**APPENDIX M
ECOLOGY MEMORANDUM
ICS Uplands Ecological Risk Analysis
October 9, 2017**

**REMEDIAL INVESTIGATION REPORT
ICS/NWC RI/FS
SEATTLE, WASHINGTON
October 2025**

ICS Uplands Ecological Risk Analysis

This memorandum represents a Department of Ecology analysis and recommendation regarding the Terrestrial Ecological Evaluation section (Terrestrial Ecologic Contact – Section V (a) (1)) of the document: *Remedial Investigation Report: Industrial Container Services, WA, LLC [Former NW Cooperage Site] Seattle, Washington. Agency Review Draft: September 2016* (DOF, 2016) (Facility Site ID No. 2154).

Appendix A: ICS Site - Exposure Pathways

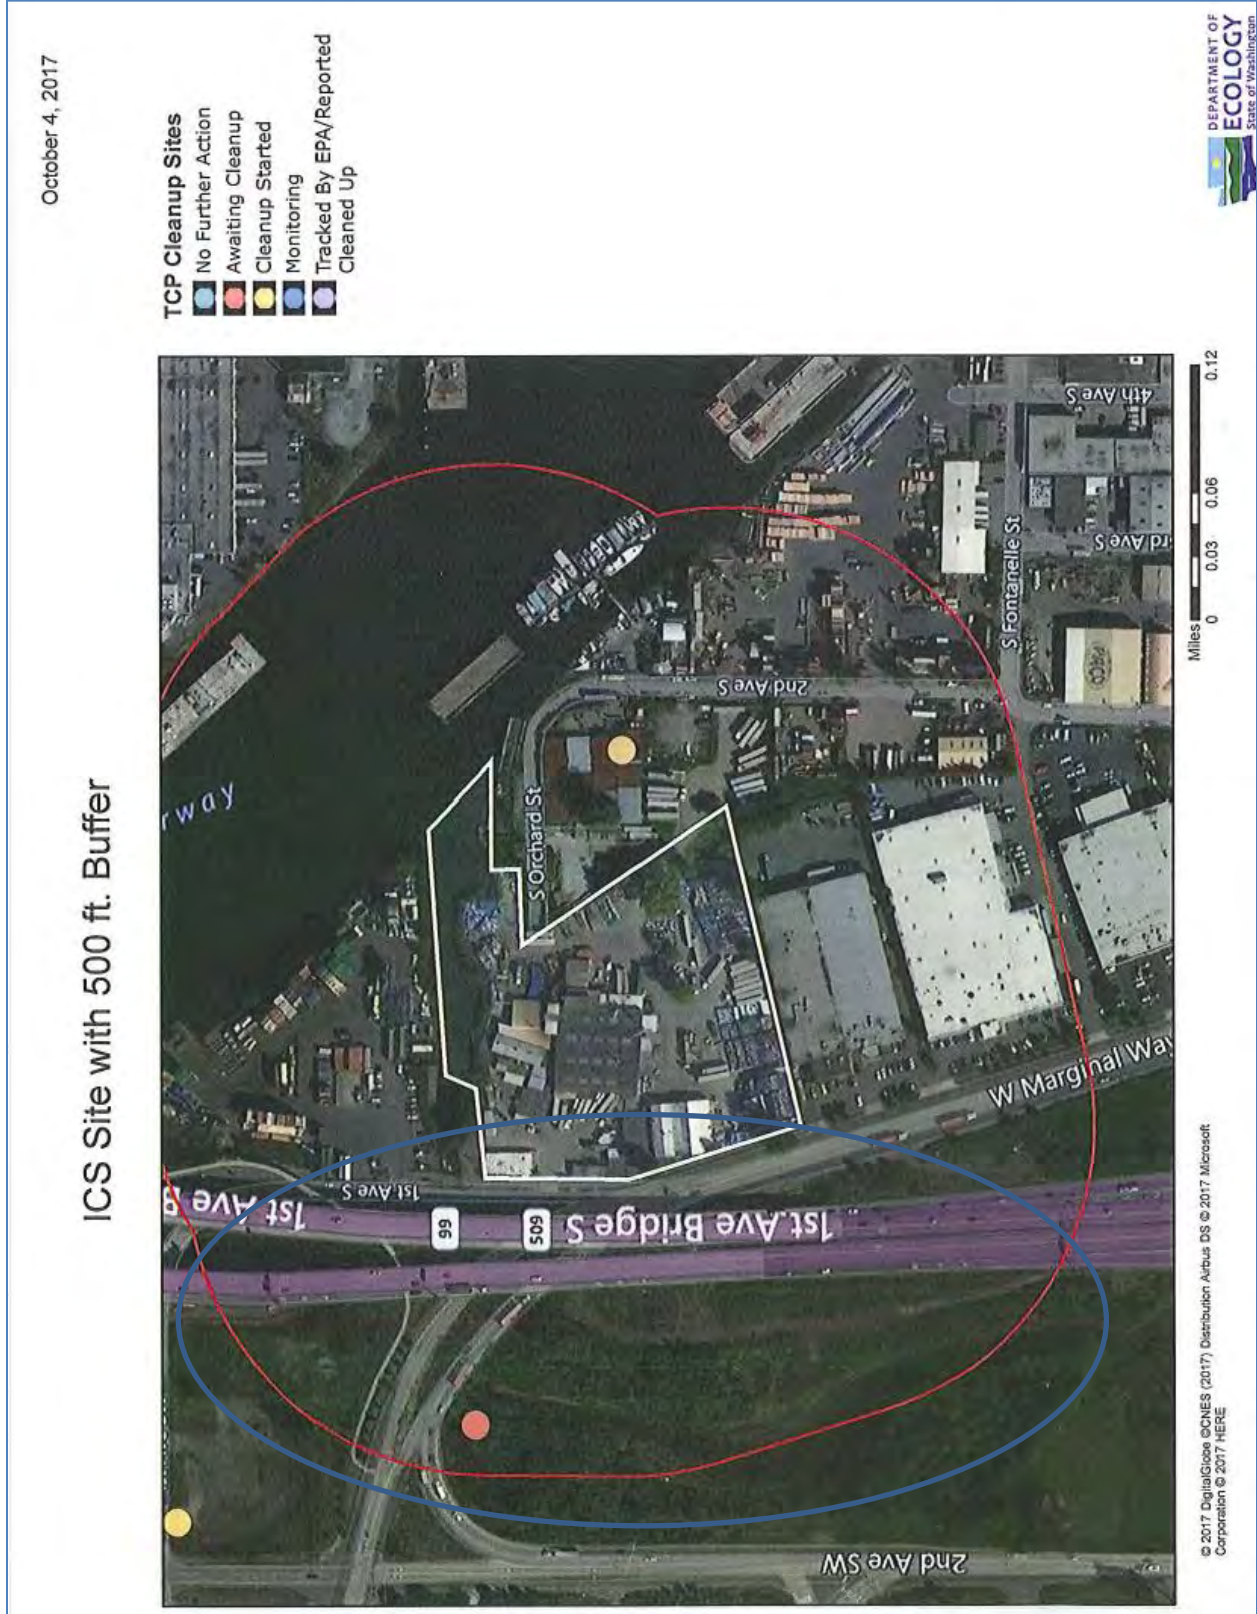
2. **Incomplete exposure pathway (340-7491(1) (b)).** Section V (a) (1) of the Remedial Investigation Report details that *“The Upland Area portion of the Site is zoned industrial and is covered by buildings and paving and satisfies the exclusion criterion in WAC 173-340-7491(1) (b).”* However, it is unclear if this exclusion would apply. It appears there is an undeveloped upland area within the site boundaries. Please see Appendix A (*ICS Site – Exposure Pathways*) and verify that in the lower right hand section of the map (within the site boundaries) there are no hazardous substances detected.

- a. Recommendation: Please verify that there are no hazardous substances detected in the undeveloped area (circled) in Appendix A. If there are hazardous substances detected, the exclusion would not apply and a simplified TEE would be necessary.
